**Before the  
Federal Communications Commission  
Washington, D.C. 20554**

In the Matter of:	)	
Digital Audio Broadcasting	)	
NRSC-5 Proposal standard for	)	MM Docket No. 99-325
IBOC	)

**COMMENTS**

Submitted by:  
Jim Trapani, President  
JT Communications  
Ocala, FL USA

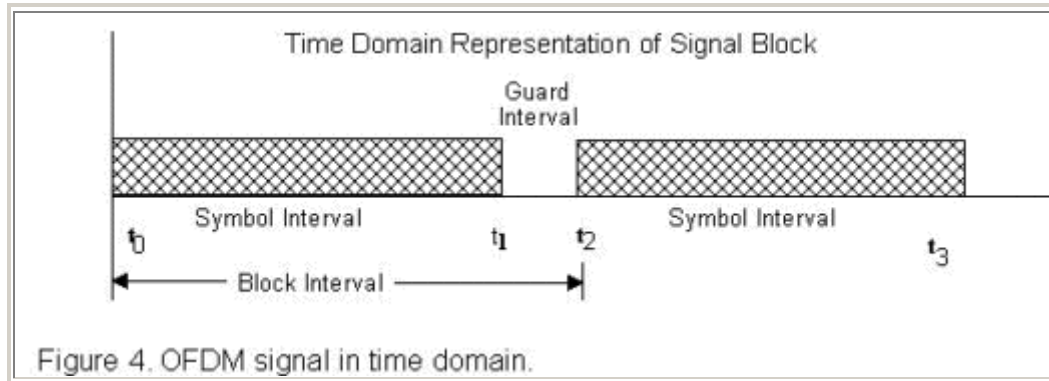
There exists improved compression standards over PAC, such as MPEG-2 layer 3 compression, which is both a worldwide industry accepted standard, and compatible with existing digital transmission standards. If incorporated with FM broadcast services, the minimum audio compression rate should be *no less than* 160 kB/s.

The audio encoding and decoding algorithm is not even mentioned in NRSC-5 documentation, but only briefly indicated in the Ibiquity white papers. Encoded audio is simply an input to the top of the IBOC stack and is not part of the NRSC-5 standard.
